MOORE SCHOOL OF ELECTRICAL ENGINEERING
UNIVERSITY OF PENNSYLVANIA

MULT. TOP CHASSIS

Drawn by:	Checked by:	Approved by:	
F. Rödl, Michael Sept. 13 1944	Z.A.S 12-15-44	AWB 12/15/44	PX-6-105

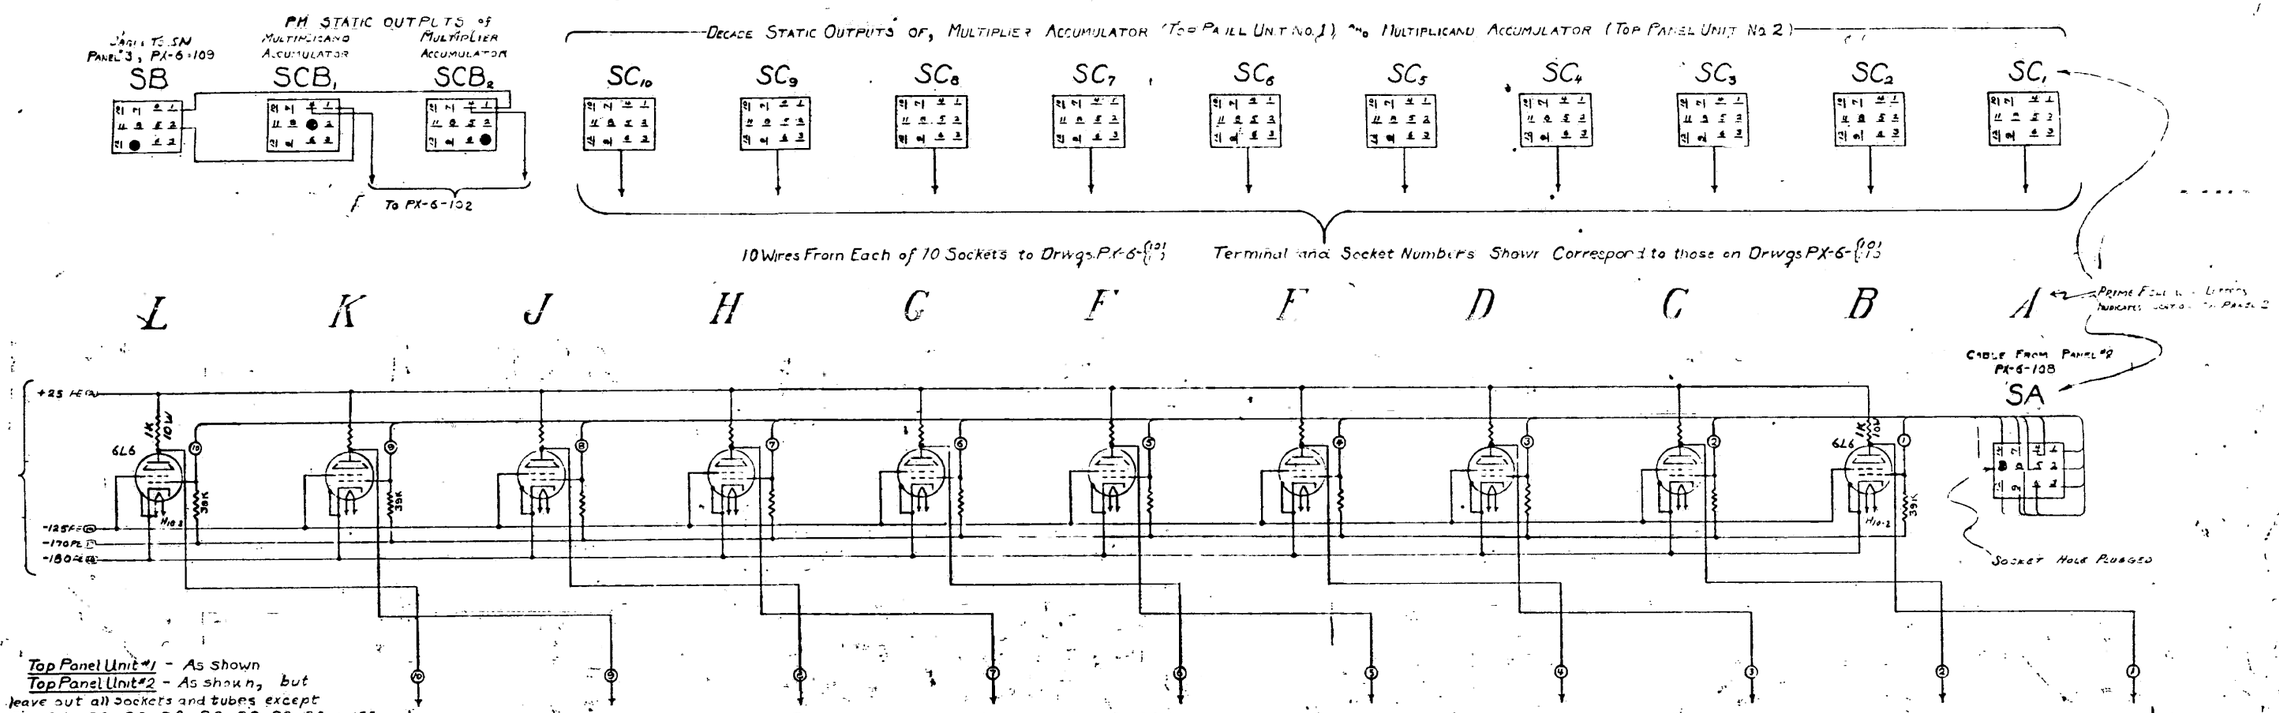
Revisions			
Cartridge SB Jks Pins Cond To Pnels #3, Now Conds 16 SN Pnels #3			
7 On SB, 5 On SCB1, 3 On SCB2			
# 11 on SN Pnels 1			
Semi-Final Revision			
Field Installation	1		
H10-2 Was H22-2			
Field Installation	2		
Outputs SCB1 & SCB2 Did Go To PX-6-101, Pnels SC1-SC10 Properly Had 9 Wires To Socket Now Has 10			
Field Installation	3
